MINUTES

Item	Description	Action	Date
1.0	Welcome and Introduction		
1.1	- TG facilitated an introduction of all attendees and introduced the project, noting that we are in the process of submitting the SDA. - Further noting subject to the SDA there will be a Territory DA submitted and that the project is trying to work through the built form so there are no surprises. - ED shared the pack and introduced the 'New Switching Stations' and 'SDA comments as the key topics for the meeting.	Note

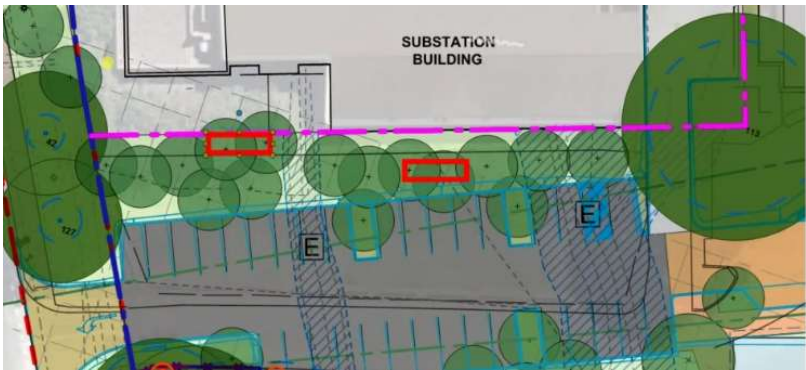
2.0	New Evo Switching Stations		
2.1	- AHj noted that 2 new switching stations are planned to be placed in the approximate locations indicated by the yellow squares are on the below drawing. - Further noting that there are multiple constraints in the area.  - NK noted that the 2 new switching stations are required to meet demand and each station is approx. 4m by 2m. - Further noting the below: - Due to the Kingston Arts Precinct Arts Pre-circulation submission Evo have gone back to the drawing board to see what is possible. - One (1) switching station works close to the existing substation, but they are unsure where they can put the 2nd switching station. - Evo are currently working with SafeEarth to figure out what is possible from an earthing perspective. ACT Survey is conducting a QL-B survey the site to determine where the cables are running. - Evo met with the Department of Finance (DoF) on the 22 May 2025 to discuss funding for the switching stations and the Department expressed their discontent with the confusion created by the redesign. - Switching stations need to be ordered by August 2025. - One option dependent on what the SafeEarth survey reports is to put both switching stations alongside the current switching station in the green verge (highlighted orange below).	Note
